**AN BORD PLEANÁLA**LDG- 017 733-19

PL06F.304624

Submission of observation Re: Application for approval to An Bord Pleanála by Fingal County Council to carry out a proposed development (Broadmeadow Way), consisting of new greenway (shared footpath and cyclepath), between Malahide Demense and Newbridge Demense.

O'Hanlon's Lane Residents Association submit an observation with respect to the above-mentioned proposed development by Fingal County Council.

Photograph 1: Exiting trimmed Hedge at southern end of O'Hanlon's Lane are not consistent with the provision of safe passing width for pedestrians and cyclists

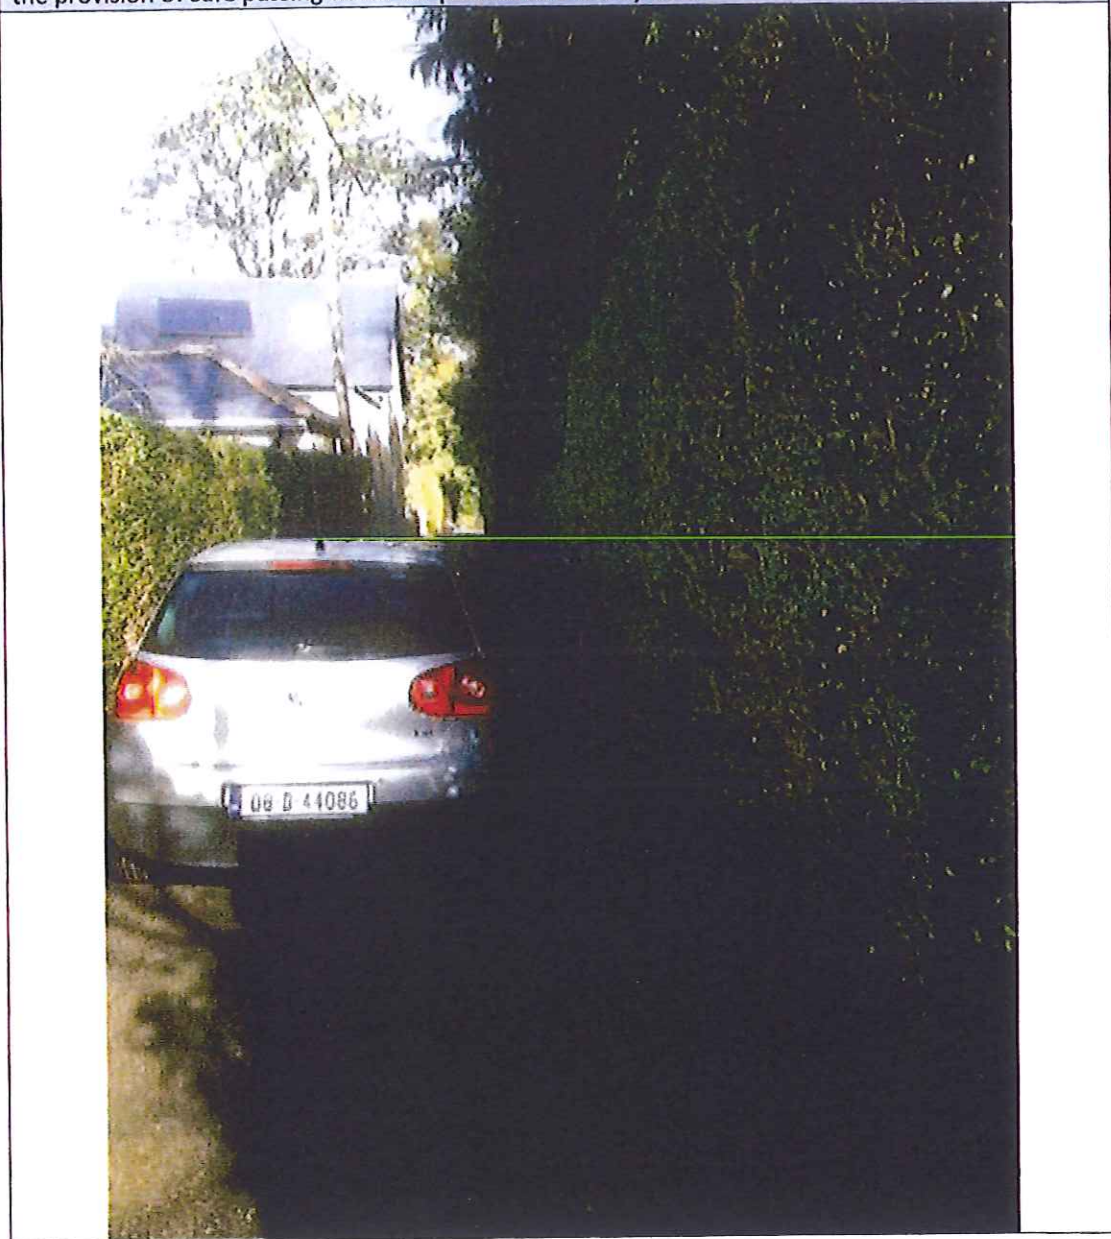
- There document suggests wider widths can be achieved through "Minor Trimming" of hedges. The hedges on southern end of O'Hanlon's lane have been trimmed back in recent months given spring and summer growth and the narrowest point of the lane measures a width of 2.4M

Outlined below are Photographs 1 & 2, showing hedgerows at the southern end of the lane where hedge trimming is proposed. The photographs demonstrate that these hedges are already well maintained and trimmed back regularly by residents.

**Image 1: Source: Google Maps showing the existing junction at the Southern/Malahide Road end of O'Hanlon's Lane**

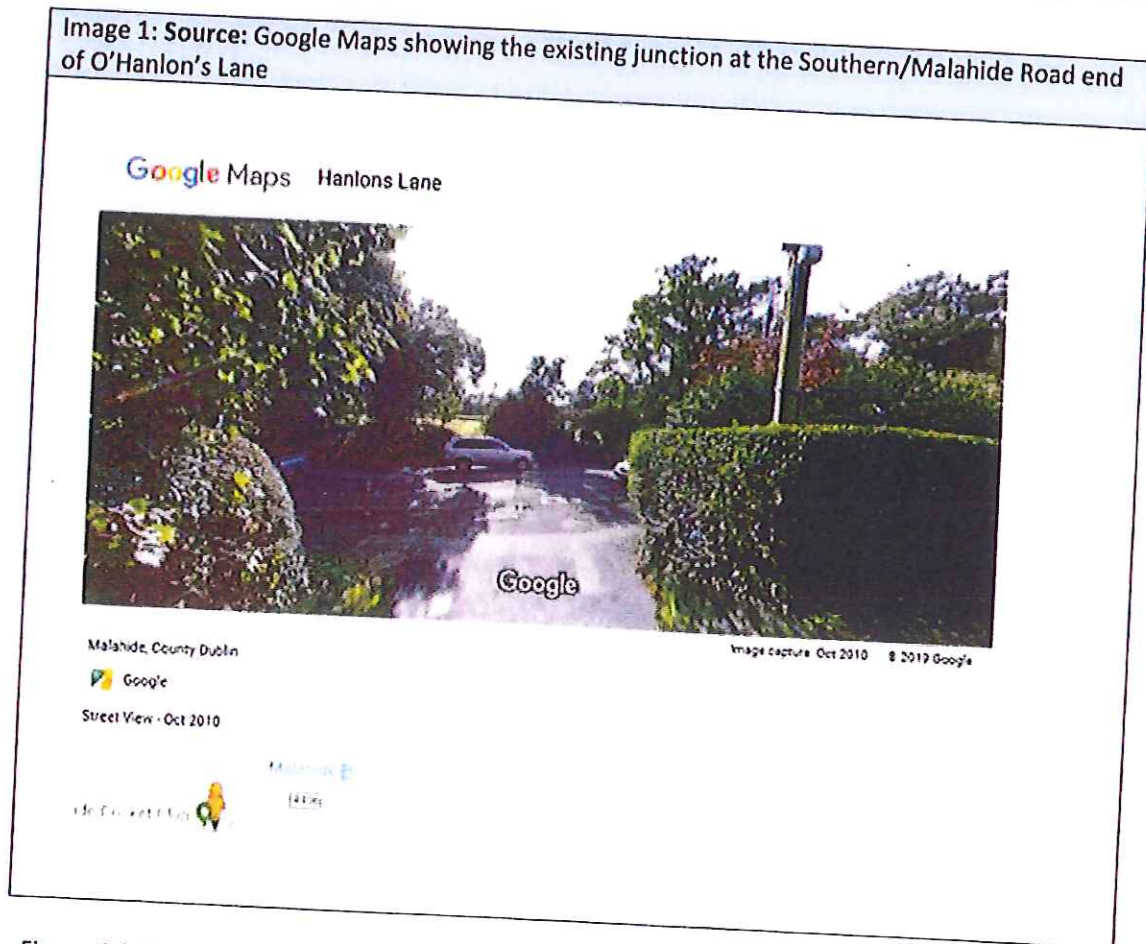
Image 1 below is taken from Google Maps to show the existing junction at the Southern/Malahide Road end of O'Hanlon's Lane.

The existing junction at the southern/Malahide Road end of O'Hanlon's Lane does not meet any of the design requirements for width of a minor road, sight lines for traffic from the minor road, traffic sight lines from the major road to the minor road.

Currently it is not feasible for two vehicles to pass over the first 35m of road from the Malahide Road end as it descends on a grade of 12% from the top to a point 38m into the lane. This fails road design criteria as indicated by the IEI and RSA guidelines for design of roads. Therefore, the addition of a combined traffic and cycleway over this part of the road is designing in a feature which fails all design criteria and therefore will fail and is hazardous.

Photograph 5: Hazardous lines of sight into oncoming vehicular traffic for users at O'Hanlon's lane northern end

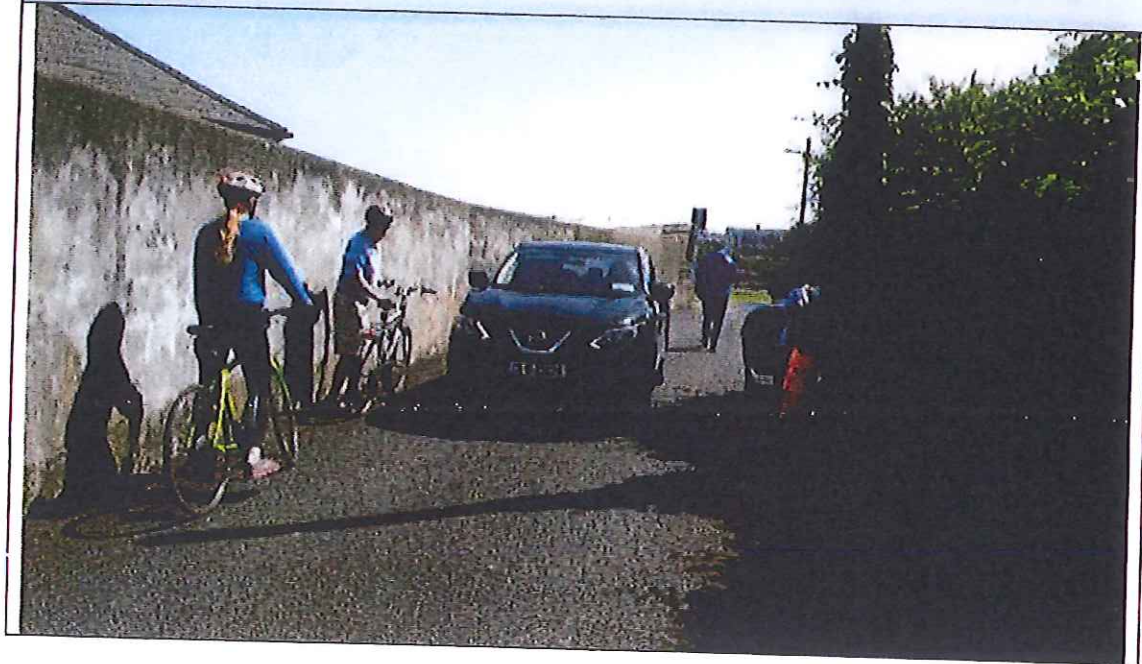
Photographs 3 - 12 below illustrate some potential sight line hazards.

Photograph 6: High volume of shared use at O'Hanlon's requires users to give way to oncoming vehicular traffic

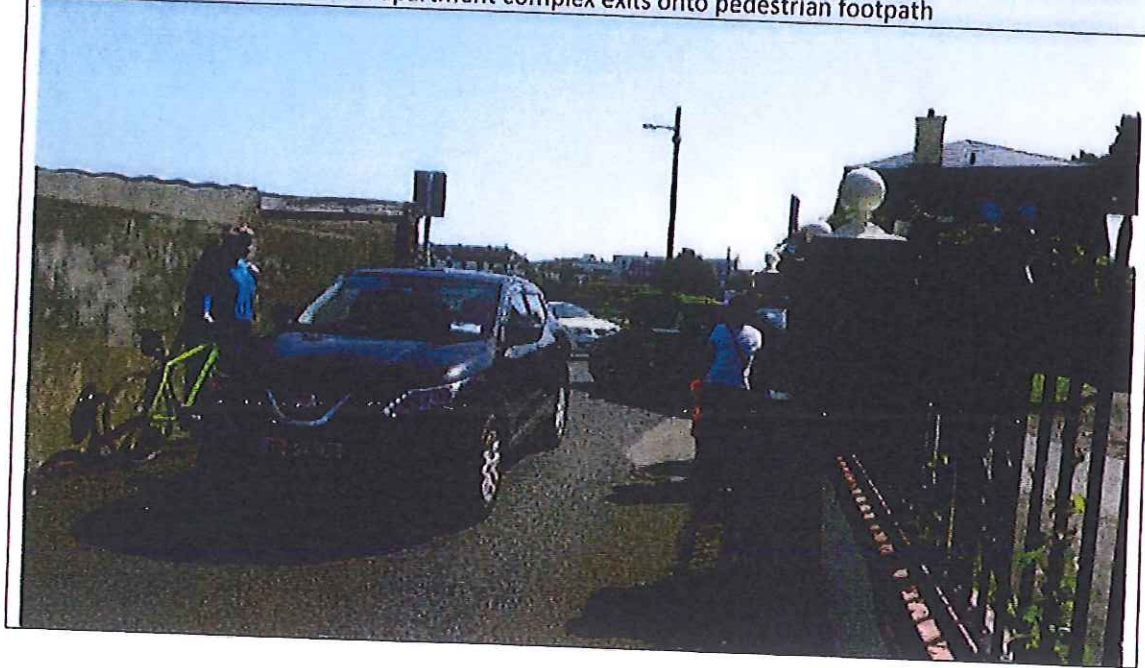
Photograph 7: High volume of shared use traffic at O'Hanlon's northern end requires users to give way to oncoming vehicular traffic

Photograph 8: Narrow blind 5-way junction at Northern end of O'Hanlon's lane – High concentration of users at this point where an apartment complex exits onto pedestrian footpath

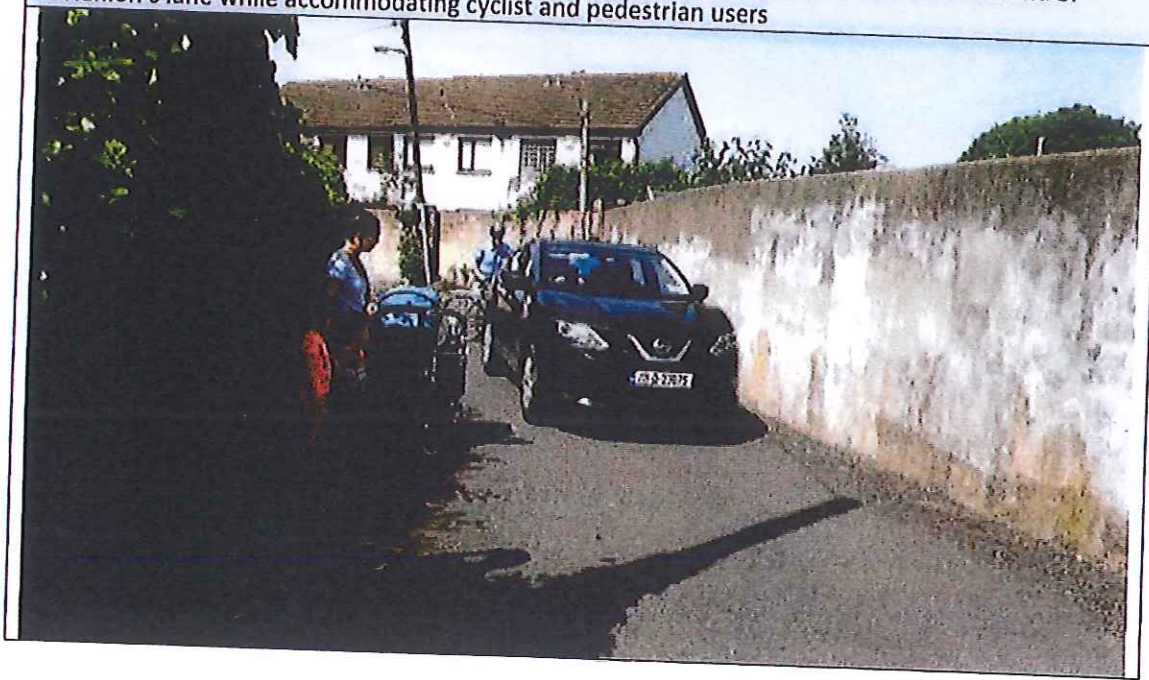
Photograph 9: Narrow blind 5-way junction at Northern end of O'Hanlon's lane – High concentration of users at this point where an apartment complex exits onto pedestrian footpath

Photograph 10: Hazardous lines of sight for vehicular traffic attempting to exit Northern end of O'Hanlon's lane while accommodating cyclist and pedestrian users

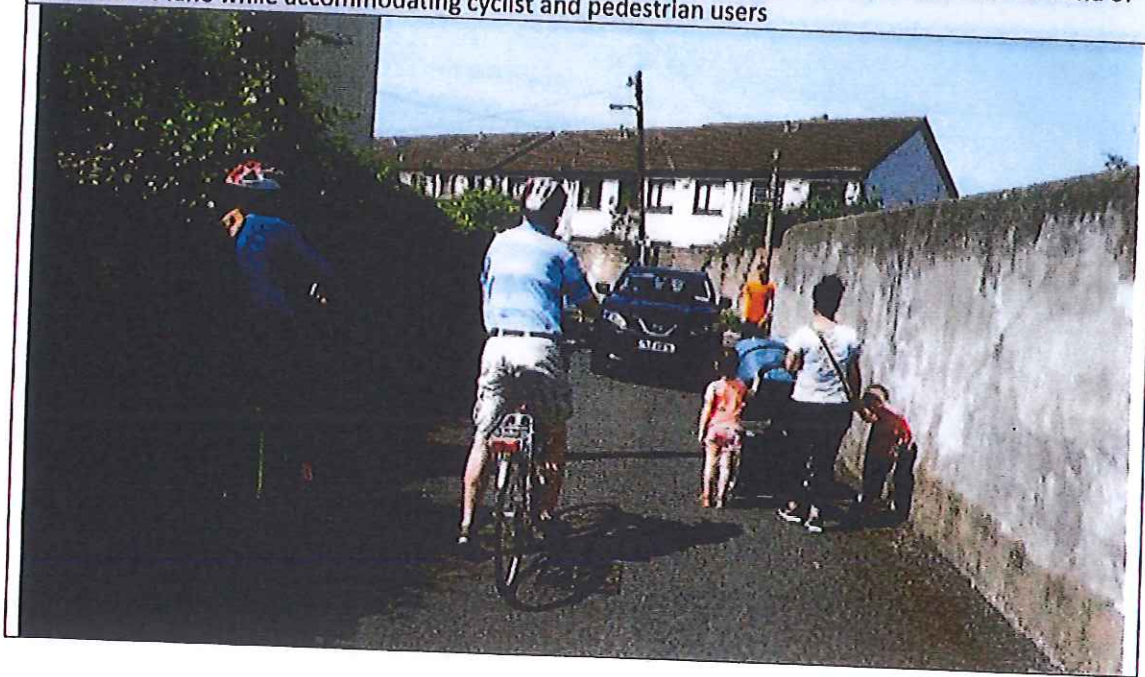
Photograph 11: Hazardous lines of sight for vehicular traffic attempting to exit Northern end of O'Hanlon's lane while accommodating cyclist and pedestrian users

Photograph 12: Unsuitable passing distances for vehicular traffic attempting to exit Northern end of O'Hanlon's lane while accommodating cyclist and pedestrian users

Photograph 13: Exiting trimmed Hedge at southern end of O'Hanlon's Lane are not consistent with the provision of safe passing width for Pedestrians and Cyclists

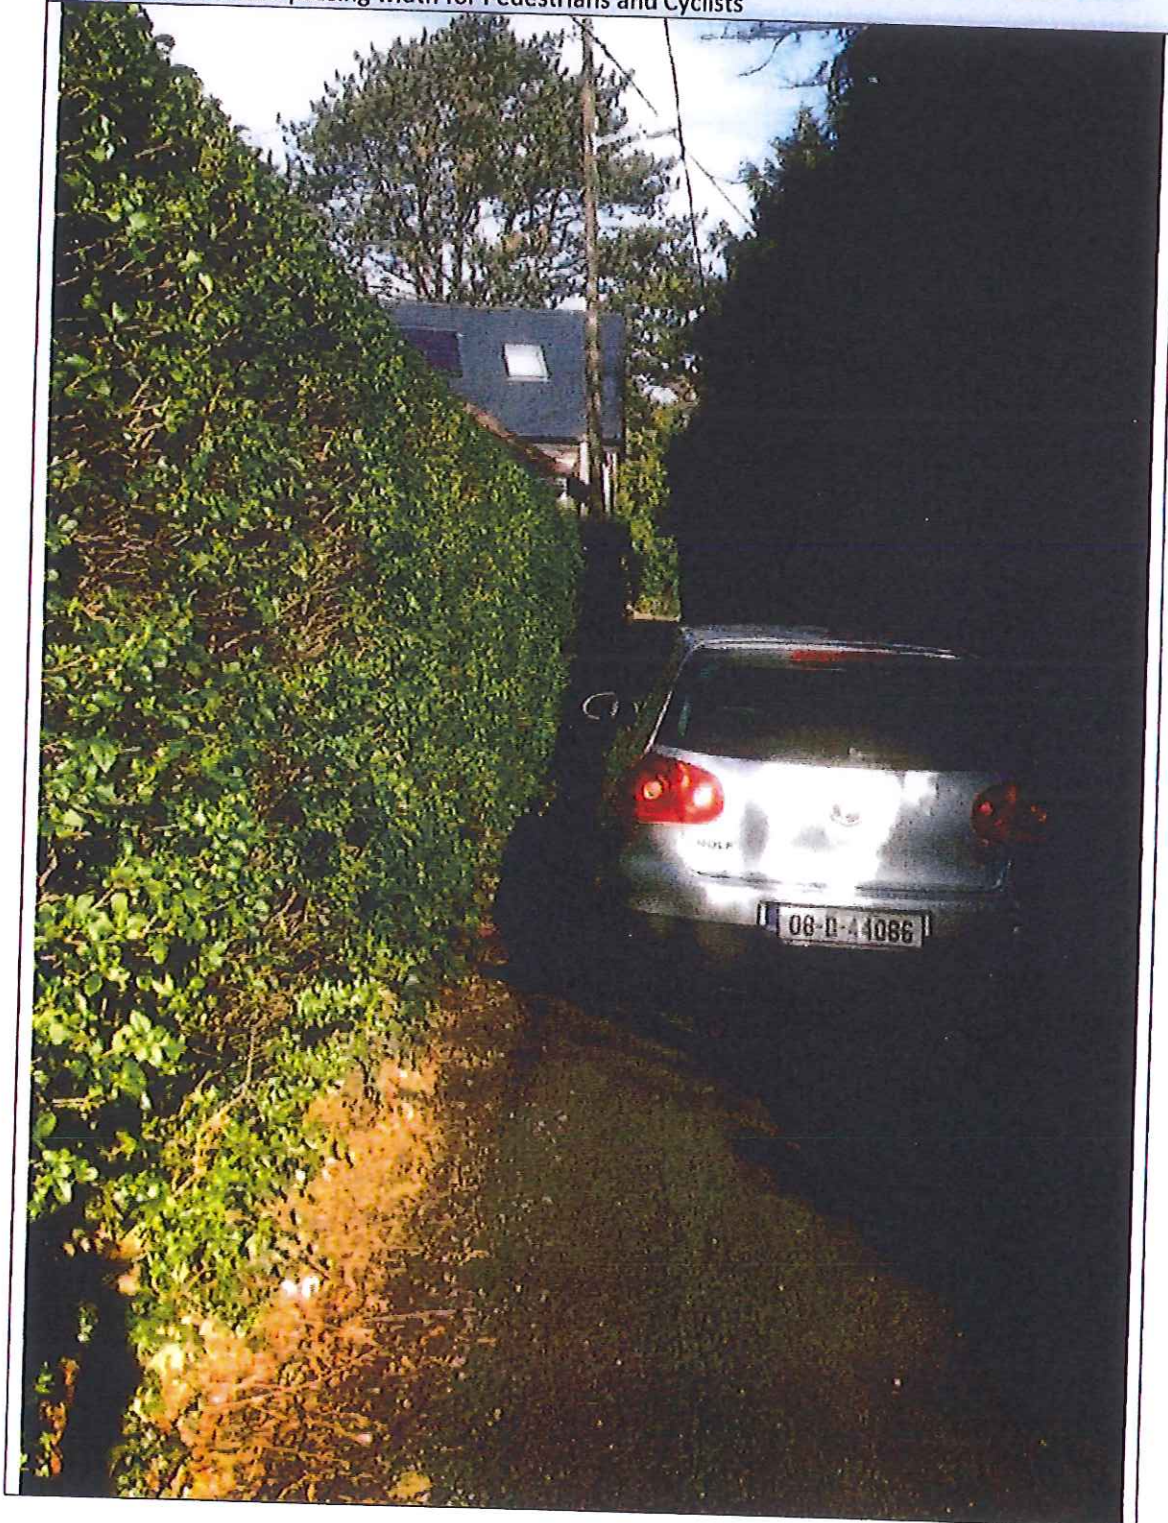
These shared sections present insufficient passing distances resulting in the need for HGVs to reverse through blind corners and vehicular blind spots for cyclists that may be abreast of the HGV. This risk was put forward in the consultative submission by O'Hanlon's residents in 2014 but has not been reasonably addressed in the council's response (refer to Figure 1 above).

Photograph 13 & 14 below illustrates insufficient passing distances. This illustration would be further compounded by oncoming HGV traffic.

Photograph 15: Street parking is an established norm for visitors and those working at or delivering to households on the lane.

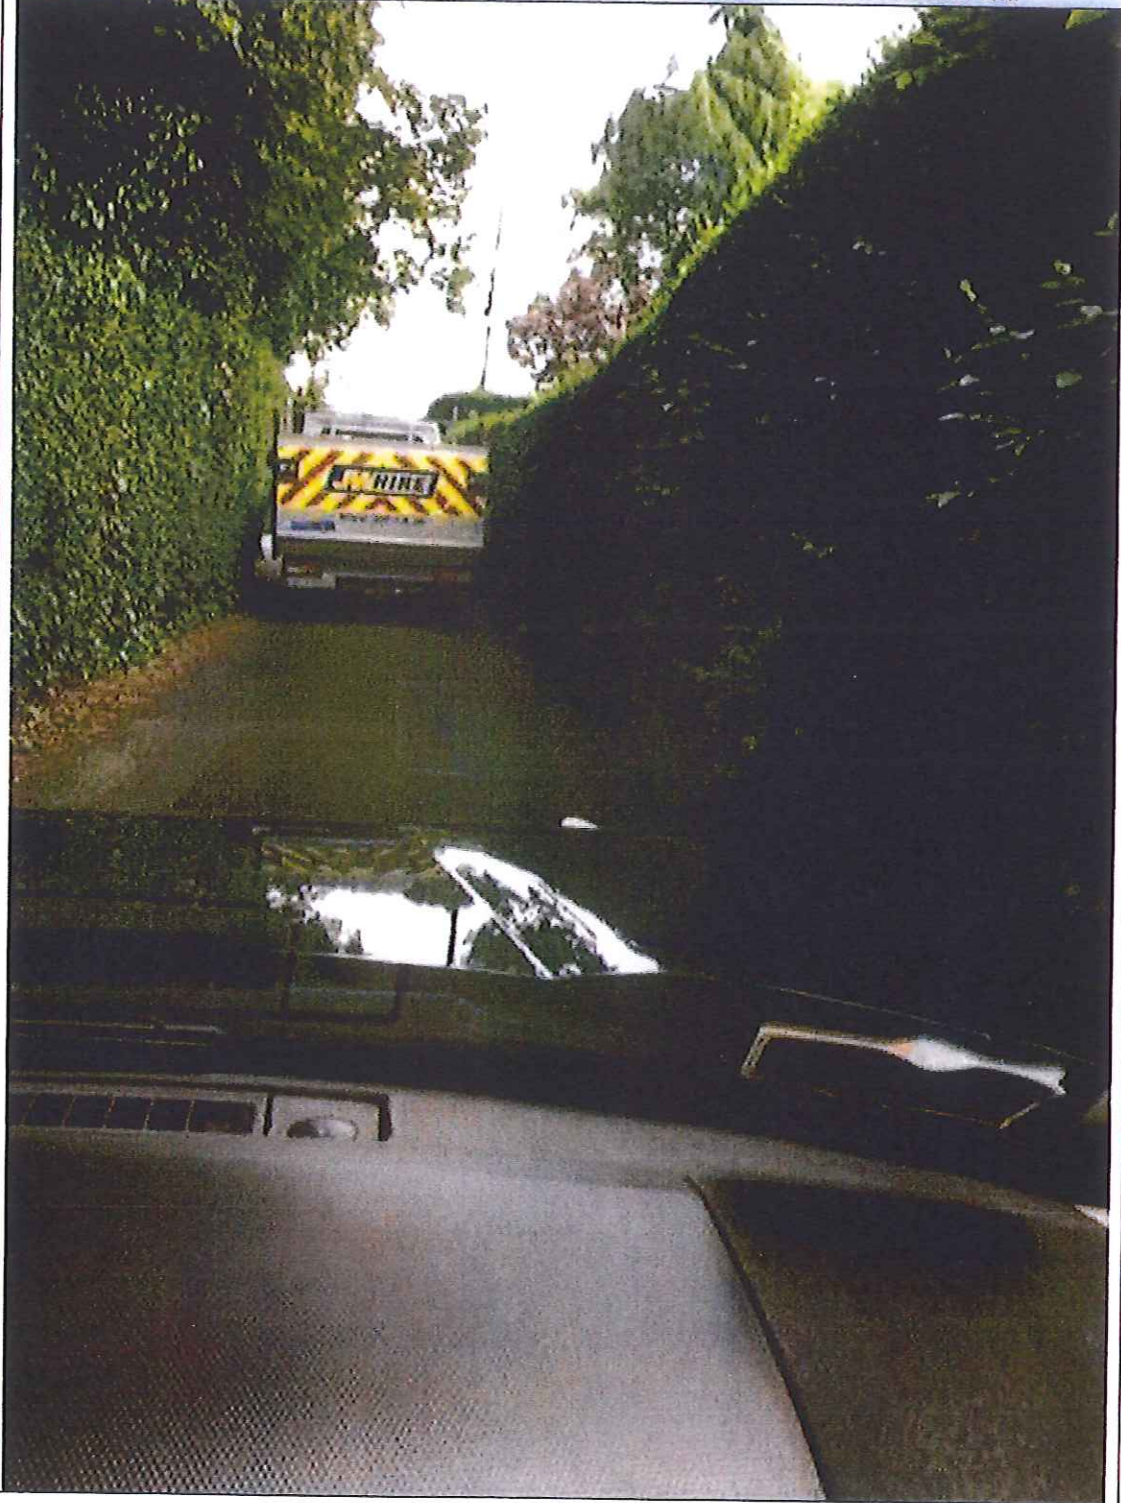
Photographs 15 & 16 below provide illustrative examples of these challenges that have not been addressed in the design.

Photograph 16: Management of HGV and Service Vehicles at O'Hanlon's Lane southern end
